DF Series PTZ Camera V5.5.8 Release Note

Firmware Basic Information	Firmware Version:	V5.5.8_180907
	SDK Version:	V5.3.6.11_build20180626
	Play Library (PlayCtrl.dll)	V7.3.5.43_Build20180705
	Encapsulation Library (SystemTransform.dll)	V2.4.0.8(20150116)
	Voice intercom library	1.1.0.8
	iVMS-4200	V2.6.10.11build20180726
	IE Client version	V4.0.1 build 180724

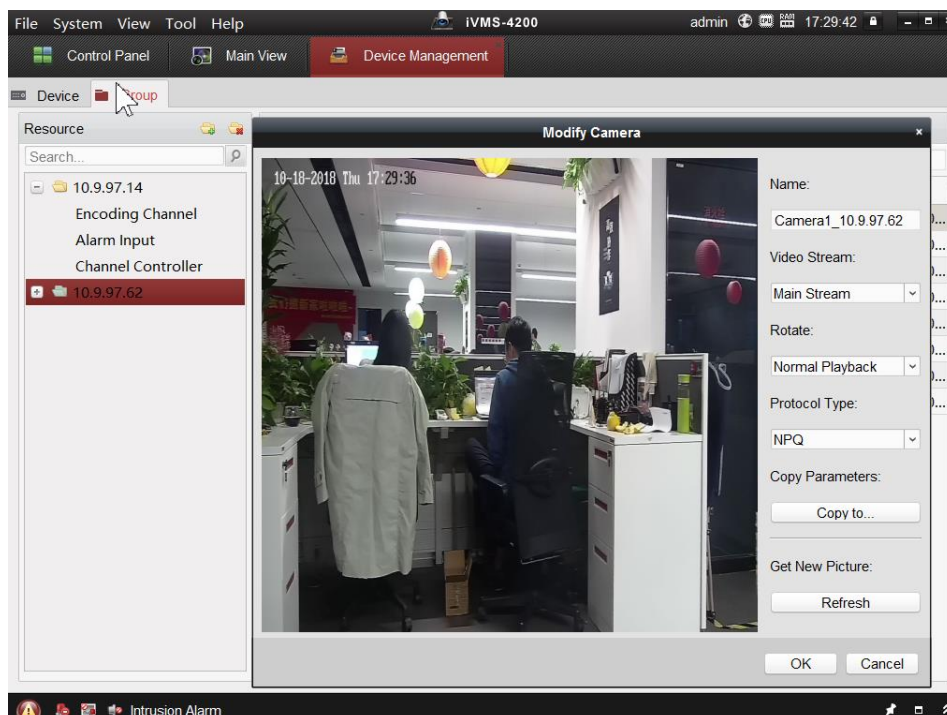
- 1) Newly support **Smooth Streaming** function, which is used to get smooth live view under poor network condition.

- Smooth streaming is only supported on third stream, there are three modes selectable: **Auto**, **Resolution Priority**, and **Error Correction**.
- In **Resolution Priority** mode, the actual resolution will not exceed the set value in the Video/ Audio interface.

- a) **Auto:** The resolution and bitrate will be adjusted automatically, the upper limits of which will not exceed the values you set on Video page. Go to Configuration > Video/Audio > Video page, set the Resolution and Max. Bitrate before you enable smooth streaming function.

- b) **Resolution Priority:** The resolution stays the same as the set value in Video page, and the bitrate will be adjusted automatically. Go to Configuration > Video/Audio > Video page, set the Max. Bitrate before you enable smooth streaming function

- c) **Error Correction:** The resolution and bitrate stay the same as the set values in Video page. This mode is used to correct the

data error during transmission. You can configure the error correction proportion within range of 0-100. When the proportion is 0, the data error will be corrected by data retransmission. When the proportion is higher than 0, the error data will be recovered via redundant data that is added to the stream. The higher the value is, the more redundant data will be generated, and the larger bandwidth is required. When the proportion is 100, the redundant data will be as large as the original data.

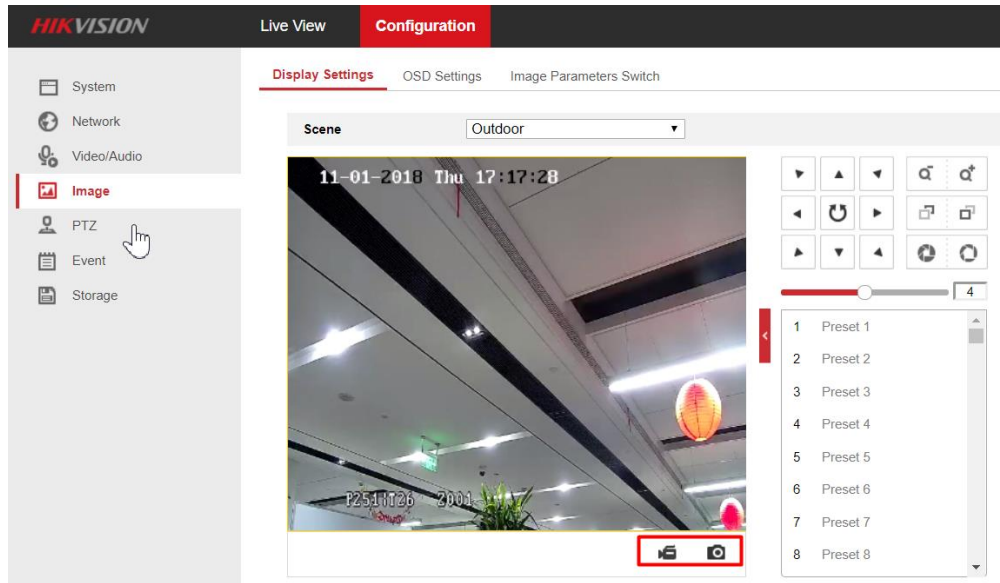
- 3) Add **Start recording** and **Capture** button on the **Image→display settings** interface.
